# Staff Report

**To:** Salt Lake City Planning Commission  
**From:** Amanda Roman, Urban Designer  
801-535-7660 or [Amanda.Roman@slcgov.com](mailto:Amanda.Roman@slcgov.com)  
**Date:** April 26, 2023  
**Re:** PLNPCM2022-00866 Design Review  
PLNPCM2022-00867 Planned Development

## Design Review // Planned Development

**PROPERTY ADDRESS:** 401 W 900 S, 954 S 400 W, 402-406 W Fayette Avenue  
**PARCEL ID:** 15-12-179-009, 15-12-182-006, 15-12-182-003, 15-12-182-004, 15-12-182-005  
**MASTER PLAN:** Downtown Plan  
**ZONING DISTRICT:** CG – General Commercial

*Building 2: Northeastern corner with two levels of retail on the corner of Montague Ave & 400 W*

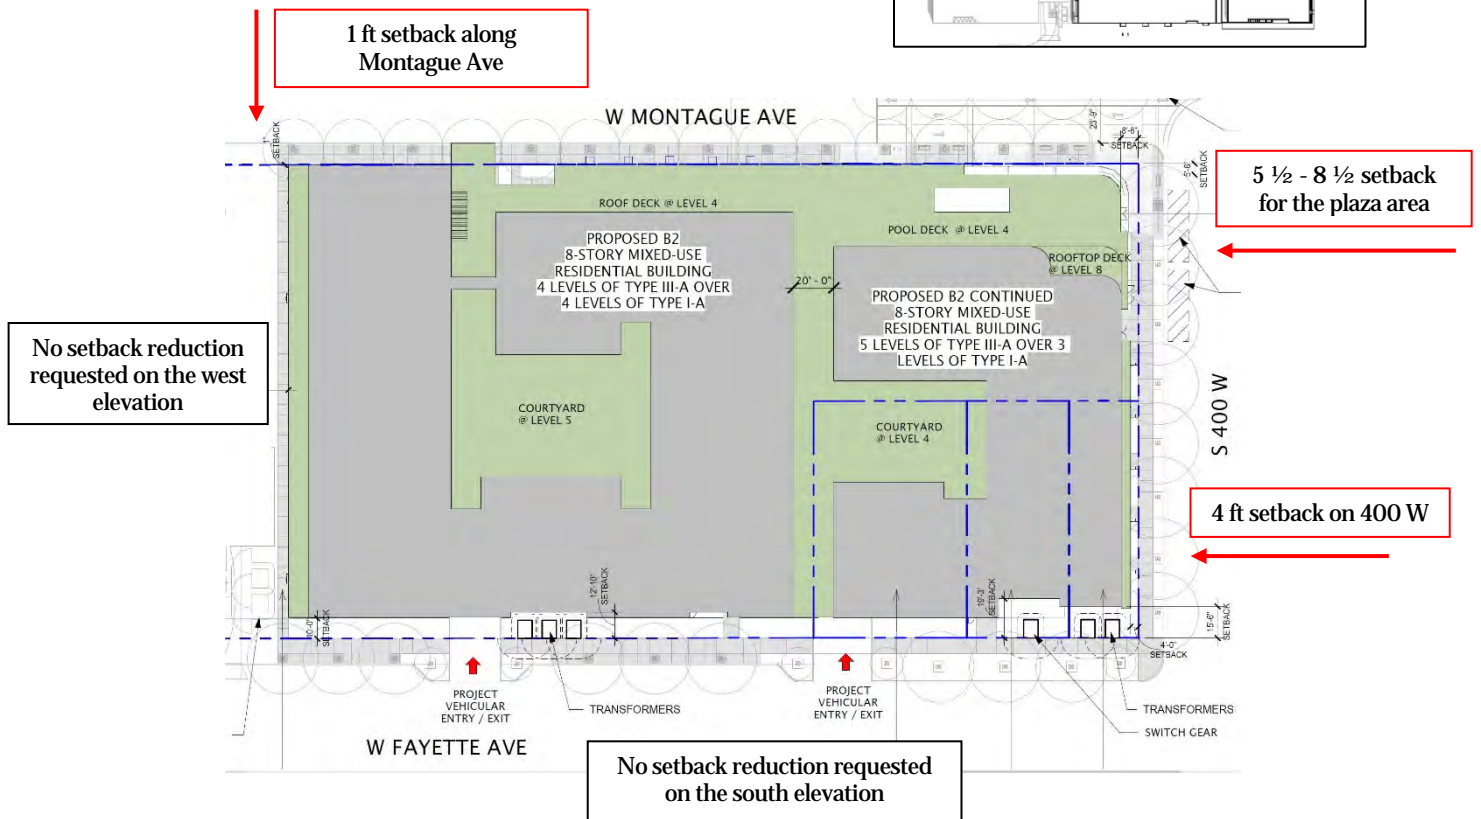
The northwestern corner of Building 2 is setback from the street 5 1/2 - 8 1/2 feet, creating a small public plaza. The corner is wrapped with two stories of retail and amenity space, and one story (level 3) of residential units. The corner of the building steps back above the second story retail space by 10 feet. The second step back is above the third floor residential units and is approximately 40 1/2 feet in depth from the property line. The 45-foot step back provides room for indoor amenity space overlooking Montague Avenue and a rooftop pool deck on the corner of Montague Avenue and 400 West.

There is no setback relief being requested for the southern and western building elevations. The building is setback between 10 and 15 1/2 feet from the southern property line along Fayette Avenue and 10 feet from the western property line, where the building abuts the Life-Science building and plaza to the west.

Building 2: Ground level landscaping plan

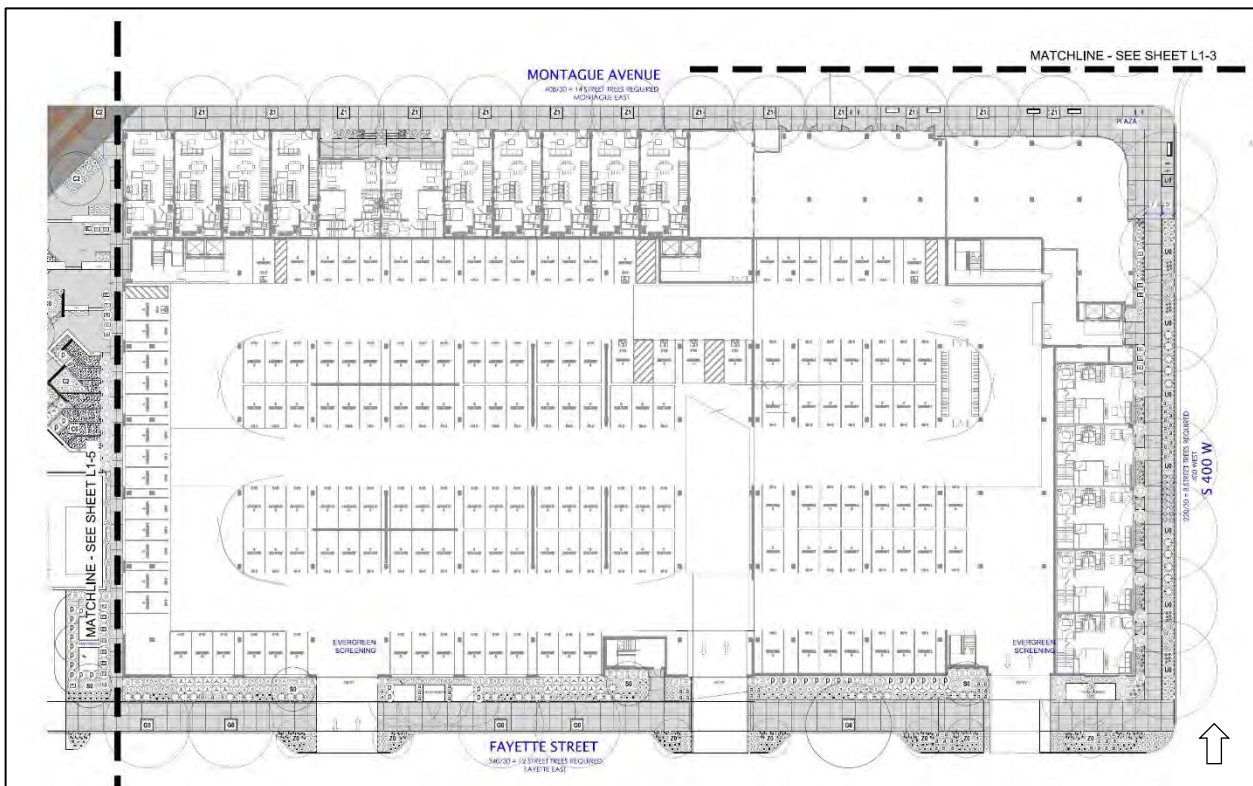
The CG General Commercial zone requires a 10 foot landscape yard on all front, rear, or corner side yards. If reduced setbacks are approved through the Planned Development process, that would likewise reduce the amount of space available for landscaping. Per section 21A.48.090, *landscape yards are yards devoted exclusively to landscaping except for driveways and sidewalks needed to serve the use or buildings on the lot that are located within the required yard.* While specific improvements are not required, *at least 1/3 of the yard area must be covered by live vegetation.*

The applicant has explained that building closer to the property line not only mimics the existing setbacks within the neighborhood, but also helps to minimize the effect of the large rights-of-way of 900 South and 400 West. A uniform and transparent street wall allows for more pedestrian interaction with the retail space along the Montague Avenue and 400 West street frontages. The buildings transformers are located within the 10 foot setback area along Fayette Avenue (south elevation). They are surrounded by landscaping to help mitigate their appearance. While staff supports this request, it should be noted that staff does not typically support an overall reduction in landscaping, open space, or amenities located within the public realm. The reduced landscape yard area is being mitigated through an increase in the overall proposed live plant material, new park strips, and rooftop landscaping on top of the buildings.

Building 3: Northeastern corner with ground floor retail on the corner of 400 W & 900 S

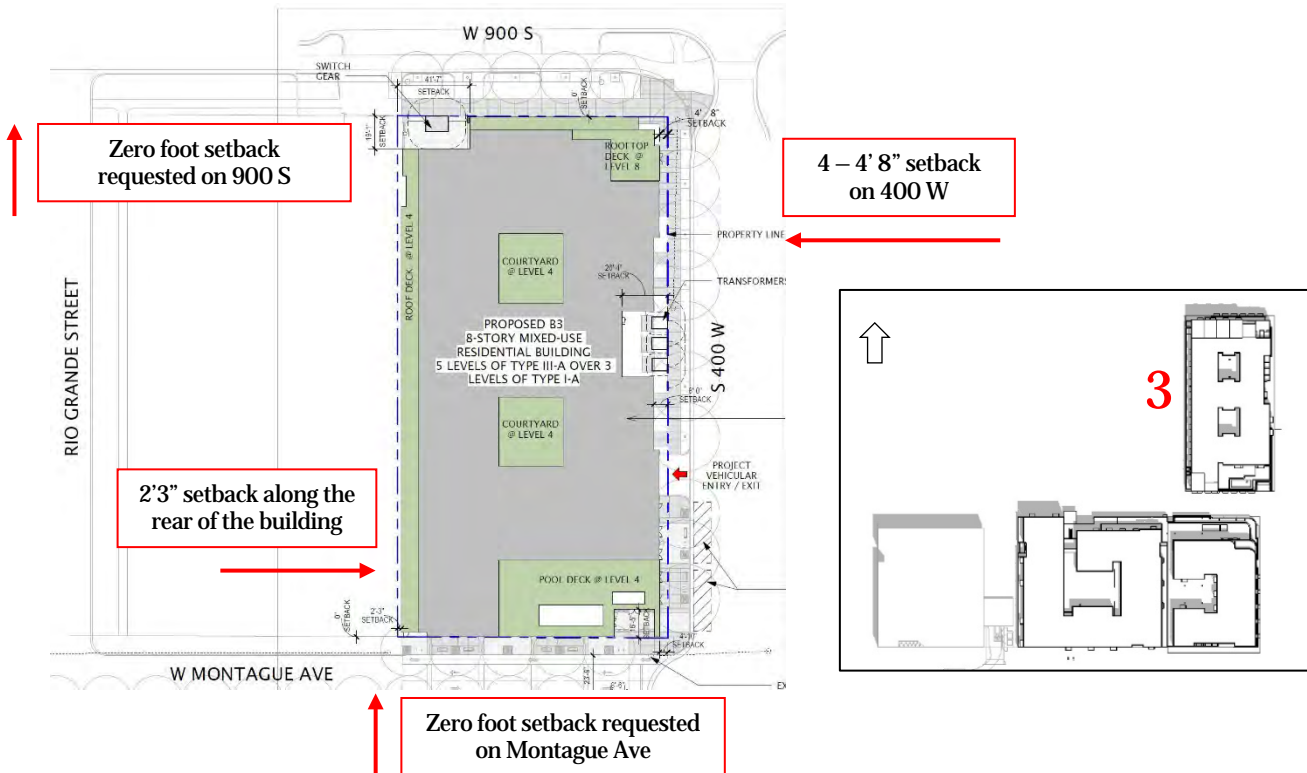
The CG zone requires a 10 foot yard setback on all frontages besides interior side yards, which this building does not have. The applicant is requesting no corner side yard setbacks along 900 South (northern building elevation) or Montague Avenue (southern building elevation). They are requesting a reduced front yard setback of approximately 4'8" along 400 West (eastern building elevation) and a reduced rear yard setback of 2'3" along the western elevation. The small setbacks allow for the ground floor retail and coworking spaces to be directly against the perimeter sidewalks.

The ground floor of Building 3 along 400 West does not have a solid street wall like the 400 West frontage of Building 2 because it is where the parking garage entrance is located. The building also carves out room for transformers on 400 West and switch gears on the northwest corner of 900 South. All ground level electrical equipment is screened by landscaping, as described below.

Building 3: Ground level landscaping plan

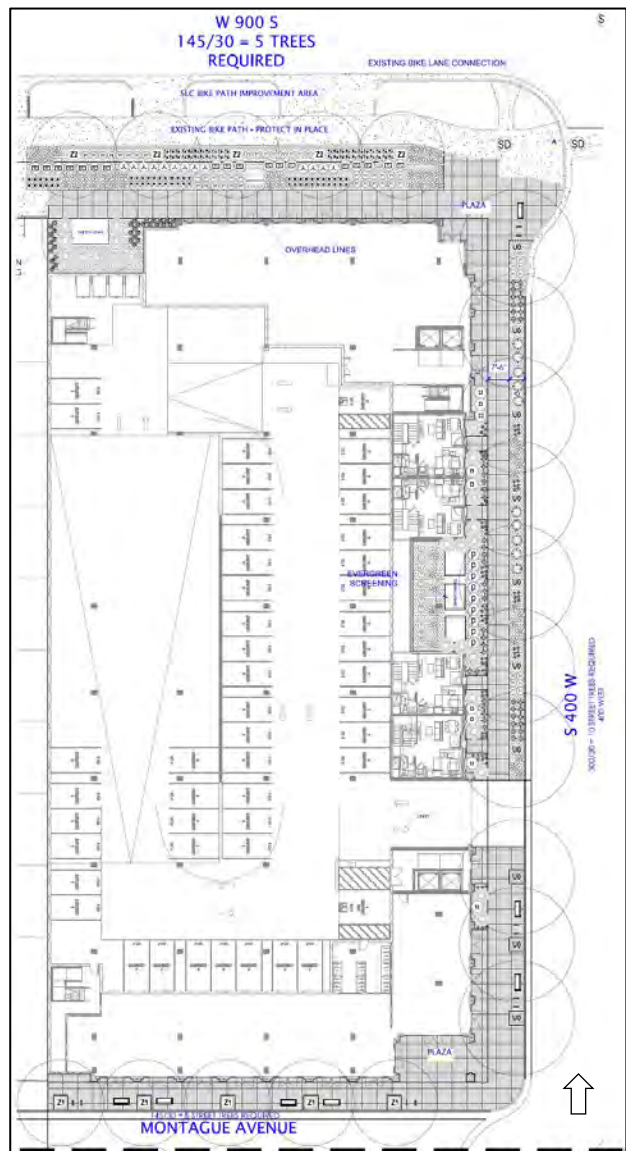
Building 3 also has reduced landscaping within the setback area due to the building being either directly against the property line or closer than the required 10 feet. The CG zone requires all the yard areas to be landscaped yards. Per section 21A.48.090, *landscape yards are yards devoted exclusively to landscaping* except for driveways and sidewalks needed to serve the use or buildings on the lot that are located within the required yard. While specific improvements are not required, *at least 1/3 of the yard area must be covered by live vegetation*.

While the landscape yard area is reduced, the provided yard areas are fully landscaped with live plant material, which exceeds the 1/3 requirement as defined in code. As mentioned above, the ground floor of the 400 West building façade indents to accommodate electrical transformers. The transformers are screened with dense evergreen shrubs (see the landscape plan in [Attachment C](#) on page 105 of the staff report). The building façade overhangs the transformer location above the third floor.
